TOWN OF PLAINFIELD BOARD OF ZONING APPEALS REPORT

DATE: November 17, 2025
CASE NO.: [BZA-25-080](#)
PETITIONER: Melissa Garrard, Pulte Homes of Indiana

REQUESTED ACTION: Variances of Development Standards

Section 7.5.A.1

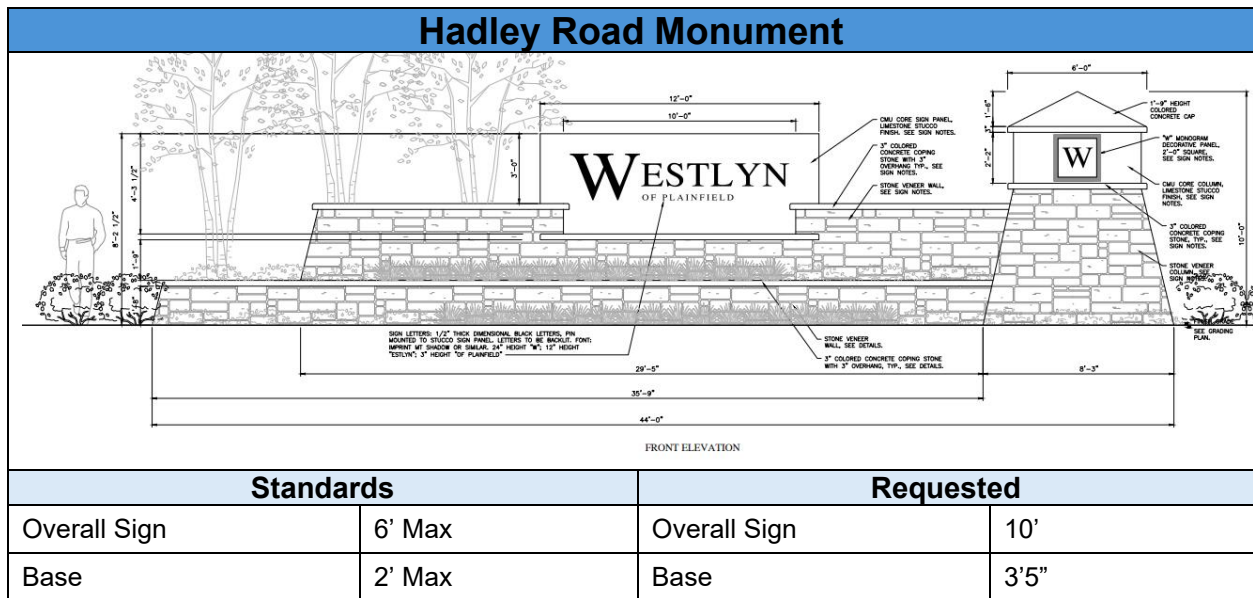
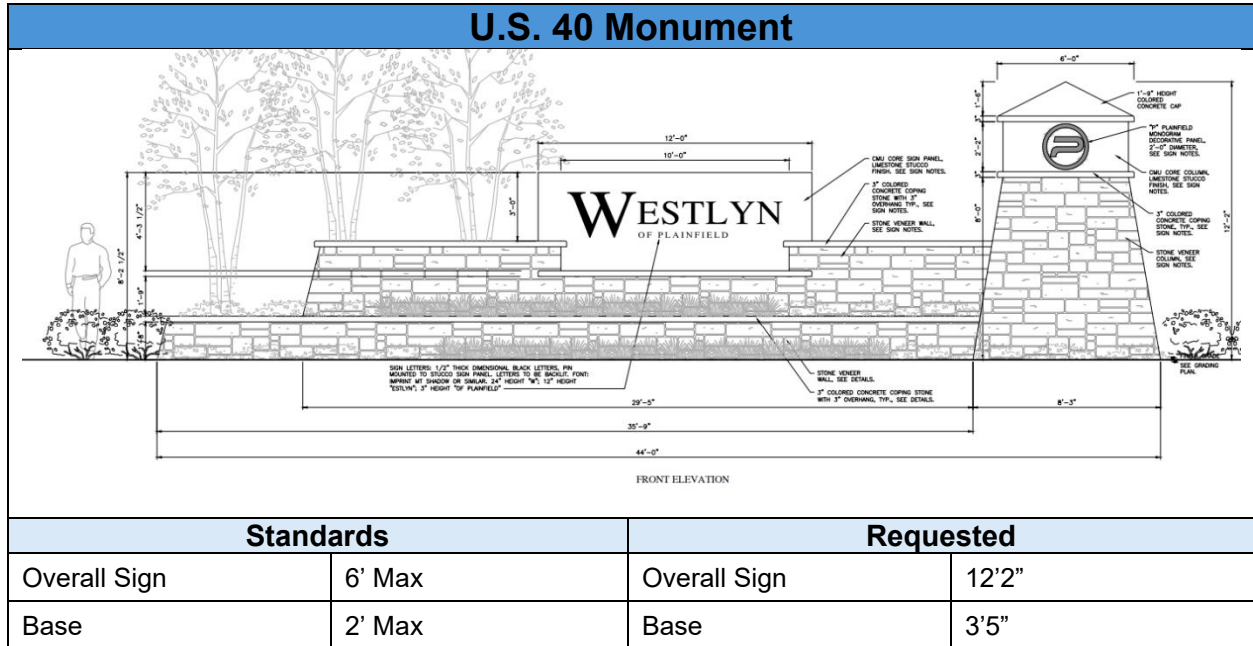
Both proposed monuments have ornamental bases that are taller than Town standards and both signs, at their highest point, are taller than Town standards allow. The "Westlyn of Plainfield" portion of the sign itself is 8'2" tall, also exceeding Town standards.

Using the applicant’s narrative, it appears that both proposed entry monuments (US 40 & Hadley Road) are intended to be applied for as a single sign each. The Plainfield Zoning Ordinance states, “the sign surface area of a ground sign shall be the smallest rectangle that can encompass all items of information” and the calculations for signage surface area below will reflect that statement. The **red outline** around each sign below indicates the smallest possible square footage measurable for each sign.

Figure 1 – Location of all proposed subdivision entrance monuments

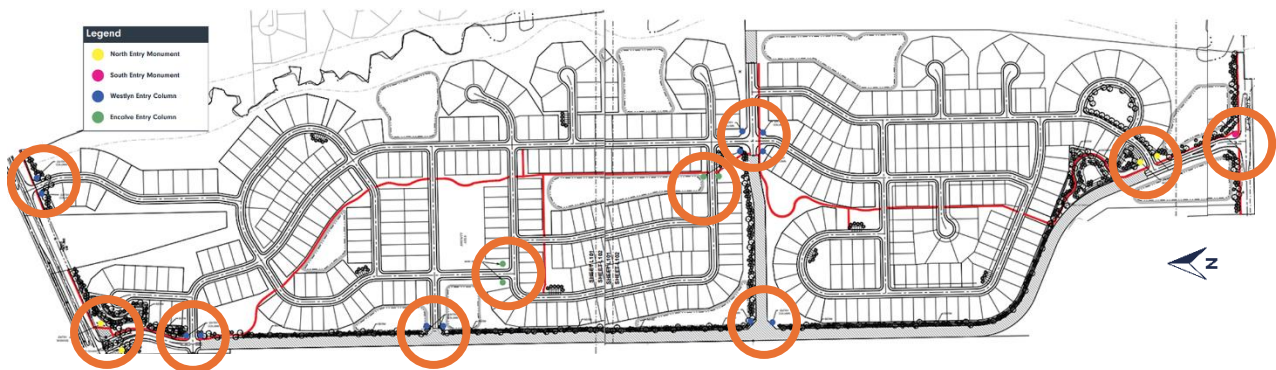
Regardless of the number of “subdivision entrances” that exist, there are more ground signs (monuments and columns) than would be allowed by the PZO. There is also inconsistency in how signs are labeled in the provided location map. On multiple occasions, the color dot & its corresponding label do not match the provided legend.

The Plainfield Zoning Ordinance specifies that two (2) signs per subdivision entrance are permitted. Figure 1 below, provided by the applicant, indicates the proposed location of all suggested subdivision entrance monuments. **Orange circles** note where the applicant proposes to place subdivision ground signs (entrance monuments and columns). The applicant’s legend and corresponding dot colors and labels are contradictory in multiple instances. A larger map may be viewed on pages 8-10 of the [Westlyn Entry Sign Exhibit](#).

Figure 2 – Subdivision entrance monuments that are/are not permitted according to the Plainfield Zoning Ordinance

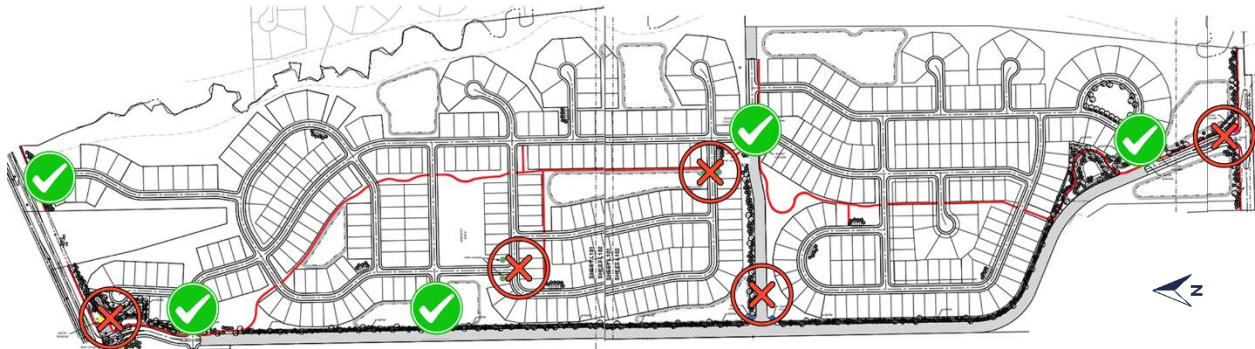
Figure 2 was created by staff to demonstrate which of the proposed subdivision entrance monuments are/are not permissible under the Plainfield Zoning Ordinance. Red X's show where requested signs would not be allowed under the PZO. Green check marks indicate permitted entrances of the proposed subdivision where signage / monumentation is allowed.

Subdivision entrance signs are only permitted at the entrance of subdivisions. The intersections of the proposed north-south collector street at both U.S. 40 and Hadley Road are not subdivision entrances. Additionally, transitional points between one housing type to another housing type (shown with green dots) within the same subdivision do not qualify as subdivision entrances.

The proposed development will have six (6) formal entrances based on current town standards, one (1) along US 40, three (3) along the proposed north-south collector street, and one (1) on either side of the proposed east-west collector street (total of 2). Exhibit 2 above demonstrates where subdivision entrance monumentation would be allowed (green check mark) without request for variance. The red X's indicate where requested monumentation would not be permitted under the PZO and would require a variance.
